## **RIVERDALE**

### **PROPOSED DEVELOPMENT, LAND AT MERCER ROAD, HORSHAM**

#### **DESIGN AUDIT**

**8<sup>TH</sup> SEPTEMBER 2025**

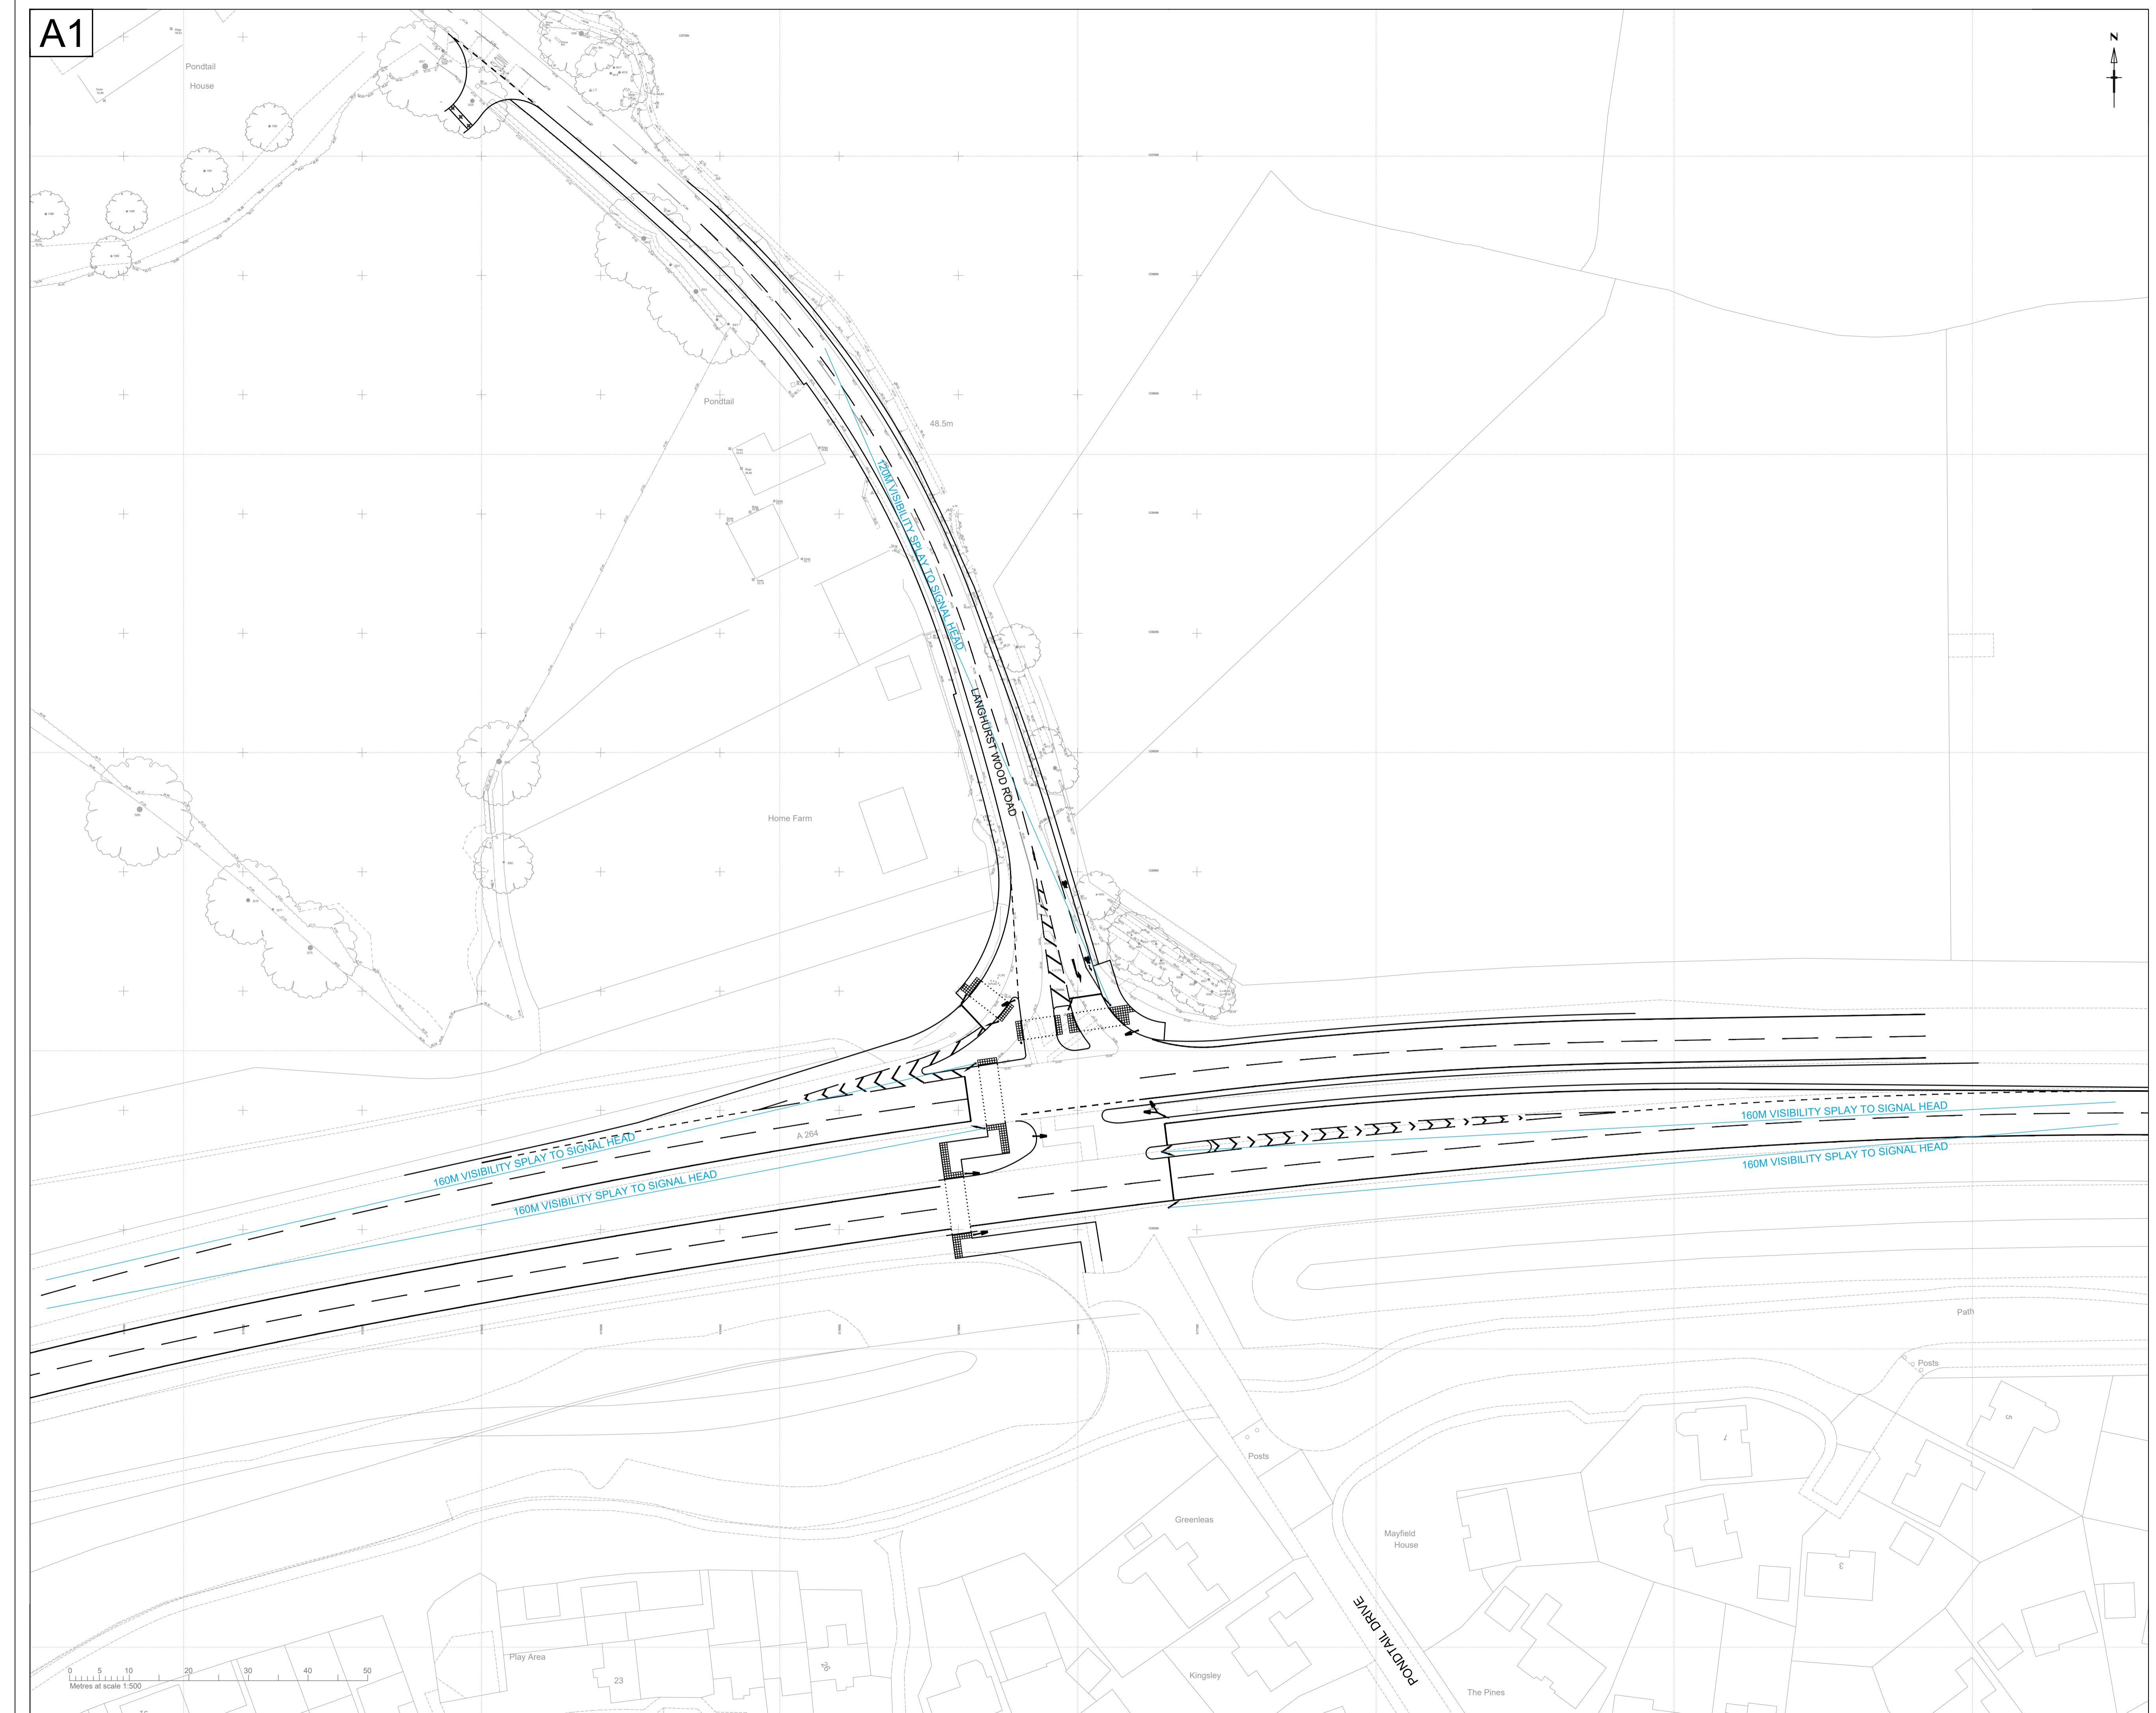
<b>7 Geometric design of signal-controlled junctions</b>	
7.1	<p>At new signal controlled junctions, the minimum intersection angle of the roads shall satisfy one of the following:</p> <p>90 degrees; or a minimum of 70 degrees.</p>
7.2	<p>Each traffic lane shall have clear visibility of at least one primary signal associated with its particular movement, from a distance equivalent to the desirable minimum SSD of the approach road.</p> <p>The proposed signal junction requires a reduction of the speed limit on the A264. For a design speed of 85kph (50 mph speed limit), clear visibility is achievable in both directions at the SSD of 160m.</p> <p>Visibility on the Langhurst Wood Road approach is achievable at the SSD of 120m for the 40mph speed limit.</p>

This is shown on drawing 17085-014 appended to this report.
7.3	Visibility to the primary signal shall be in accordance with the CD 109 [Ref 5.N] visibility envelope, but with the high object height amended to incorporate the signal head where this exceeds 2 metres, as indicated in Figure 7.3.	The appropriate visibility envelope is achievable on all approaches to the junction.

client			
RIVERDALE			
project			
LAND AT MERCER ROAD, HORSHAM			
title			
PROPOSED OFF-SITE ACCES STRATEGY SWEPT PATH ANALYSIS FTA DESIGN ARTICULATED VEHICLE			
scale 1:250	drawn by T.A.S	checked by T.B	
date SEPTEMBER 2025	status PLANNING		
drawing number 17085 - TR004		rev.

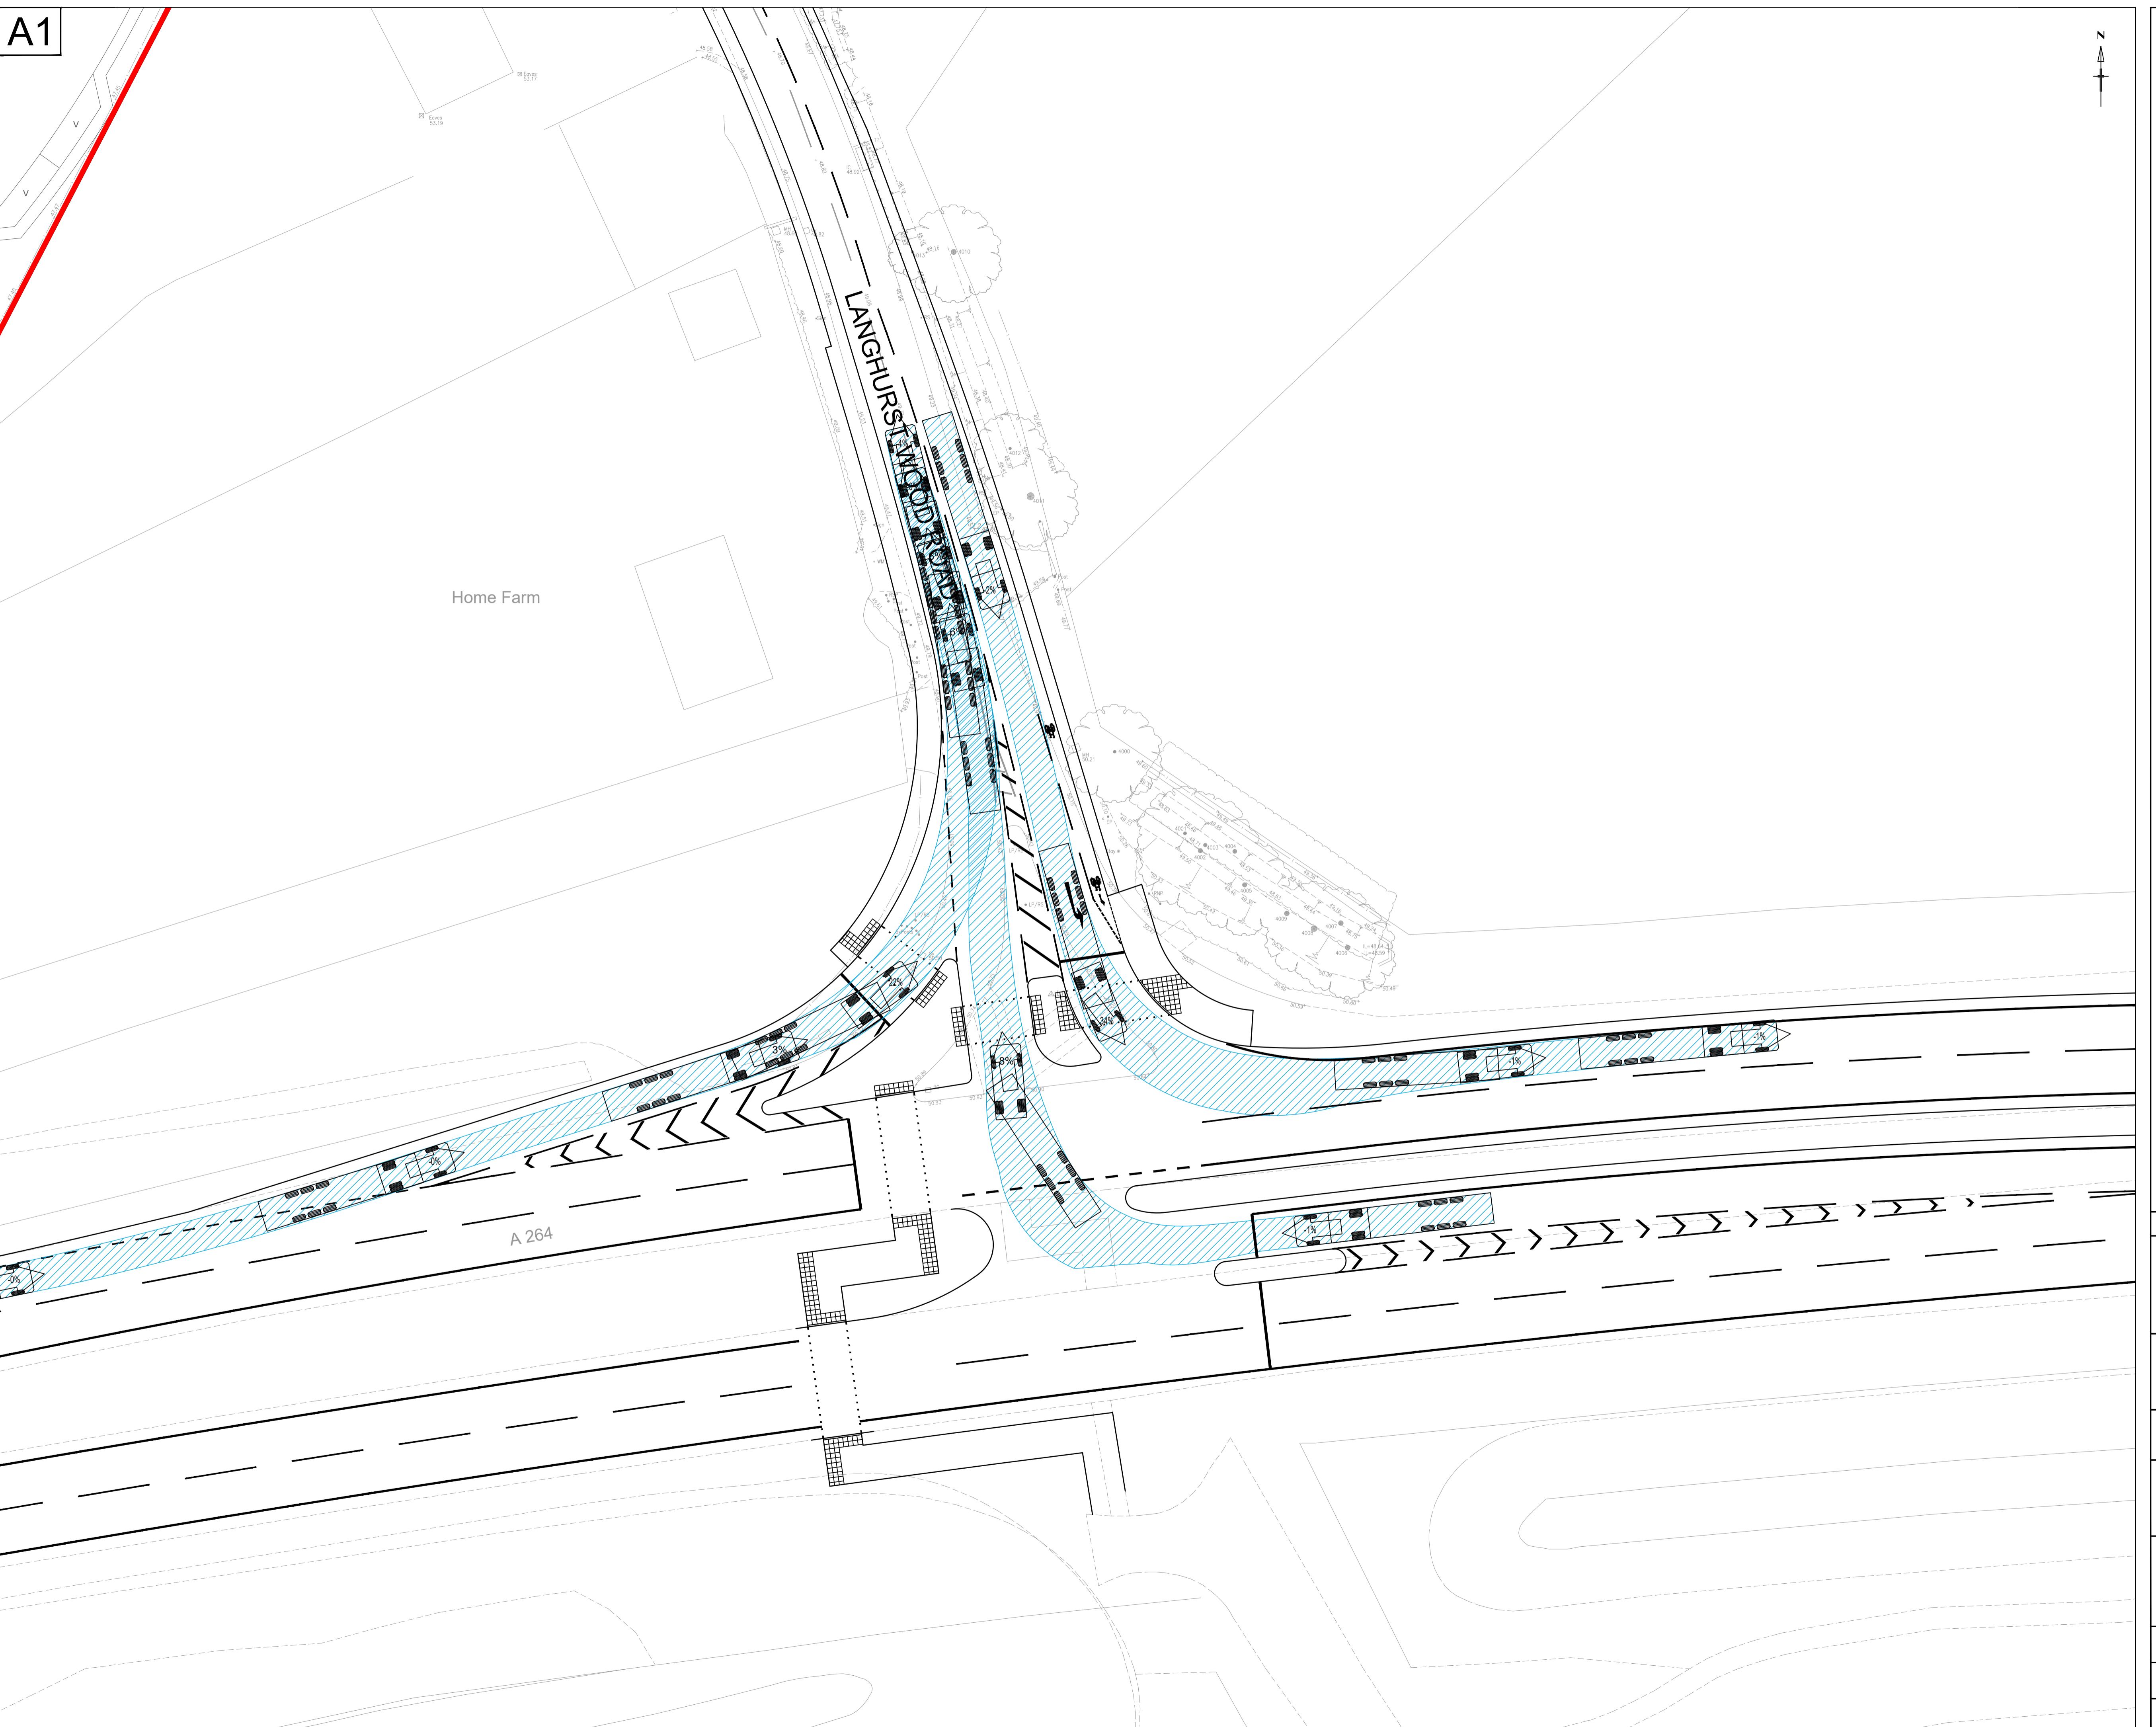
7.13	The design of a signal-controlled junction shall allow for the swept turning paths of the design vehicle where provision is to be made for large goods vehicles.	The junction has been designed to accommodate swept turning path of a 16.5m articulated truck, as demonstrated in drawing 17085 - TR004 appended to this report.

7.14	Where provision is to be made for large goods vehicles, the values for corner radii and associated tapers shall be the same as for a priority junction (refer to Section 5).	The radii and tapers have been designed to accommodate the swept path tracking of large goods vehicles as demonstrated in drawing 17085 - TR004 appended to this report.
